# **LOCAL PLANNING PANEL MEETING**

# DA/147/2022 - CONSTRUCTION OF A DWELLING HOUSE, SWIMMING POOL, SHED AND ASSOCIATED LANDSCAPING - 16 KARALEE ROAD, GALSTON

**DA No:** DA/147/2022 (Lodged 16/02/22)

Figure 1: Area shaded green for potential location of new works

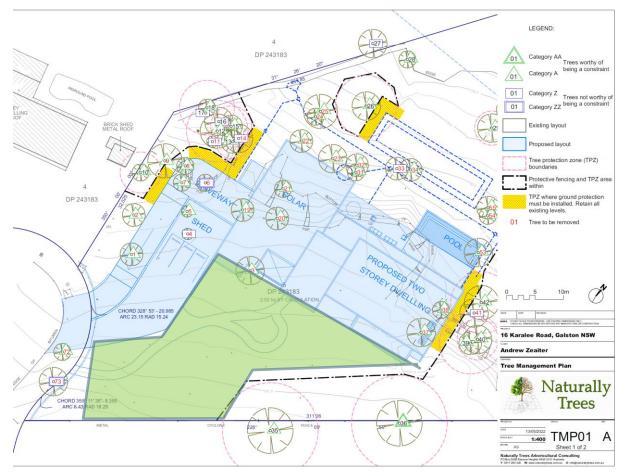
- The Tree Management Plan in the Amended Arboricultural Impact Assessment (page 30) identifies the proximity of the development to trees to be retained and removed. A fundamental issue with the design of the proposal is that the cleared land to the south has not been utilised to reduce impacts to the trees on site. The area which has been under-utilised is shaded green in Figure X below.

- Table 7 of the Flora and Fauna Report specifies that 5 of 10 hollow bearing trees will be removed. The Arborist Report only identifies tree 33 as containing hollows. While the IBVMP identifies the replacement of hollows with nest boxes at a ratio of 2:1, retention of natural habitat is always preferable.
- While the proposal has been relocated so that the APZ is outside of the C3 zone, the
  development footprint still has not utilised areas of the site which contain less trees. The Tree
  Management Plan shows the significant encroachments which will occur for the proposed
  dwelling, impacting the longevity of these trees. In addition, the 10/50 clearing entitlement will
  likely result in future removal due to overhang.
